Response Under 37 CFR §1.116
Expedited Procedure, Examining Group 3700
Application No. 10/089,247
Paper Dated: October 1, 2004
In Reply to USPTO Correspondence of June 2, 2004
Attorney Docket No. 1918-020512

AMENDMENTS TO THE DRAWINGS

FIG. 2

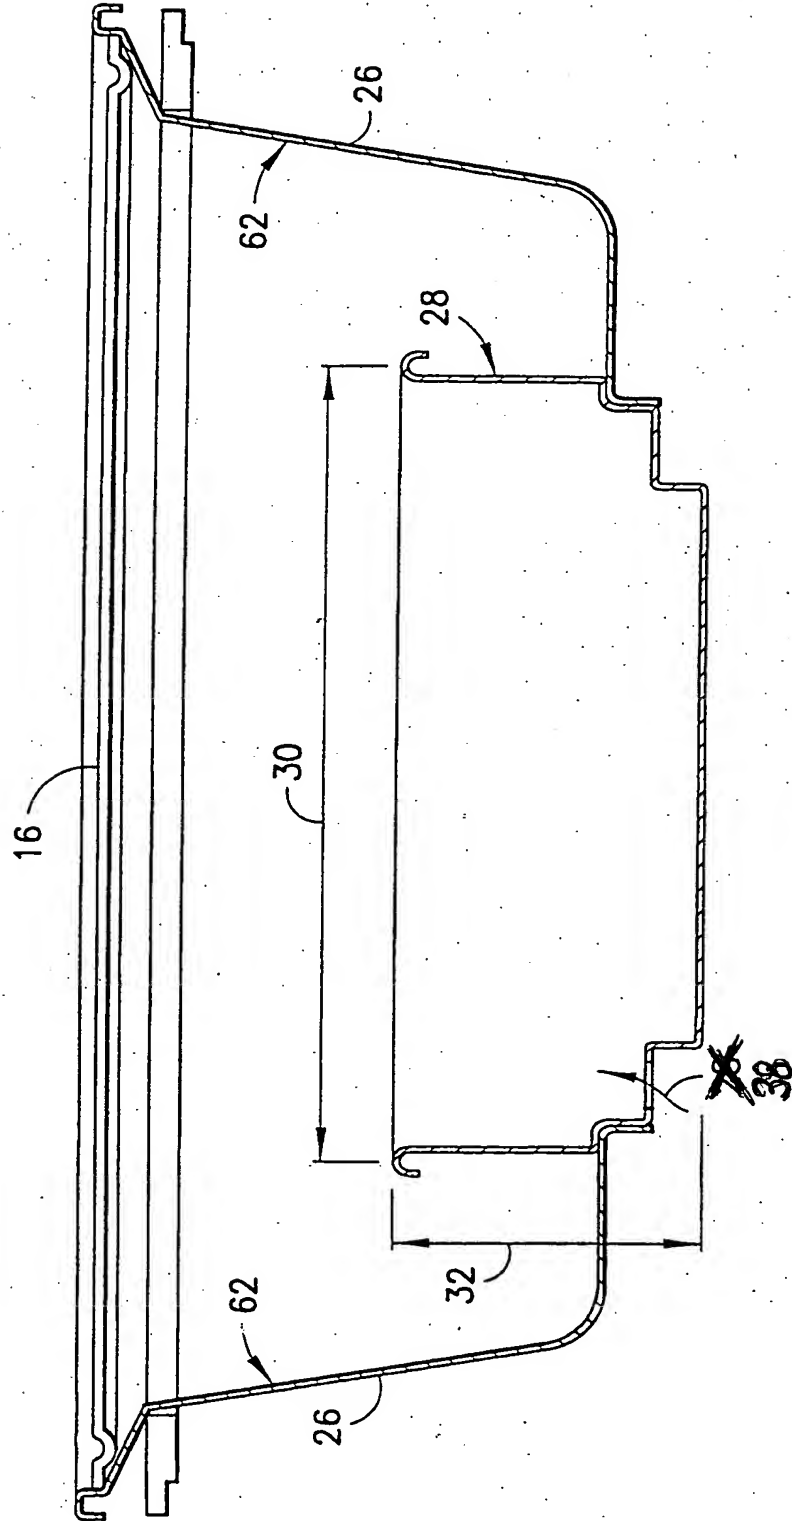
The drawings stand objected to because of certain informalities discussed on pages 3 and 4 of the Office Action. Applicant includes herewith proposed drawing changes to Figs. 1 and 2 for the Examiner's review and approval. In Fig. 1, reference numeral 57 has been changed to "56" and reference numeral 50 has been changed to numeral "57." In Fig. 2, reference numeral 28 has been changed to numeral "38." Upon acceptance of the proposed amended drawings, entry of the replacement drawing sheets of Figs. 1 and 2 are respectfully requested.

The attached replacement sheets of drawings include changes to Figures 1 and 2. The replacement sheets of drawings replace the original drawing sheets of Figures 1 and 2. Changes incorporated into the replacement sheets are highlighted in red on the attached annotated copies.
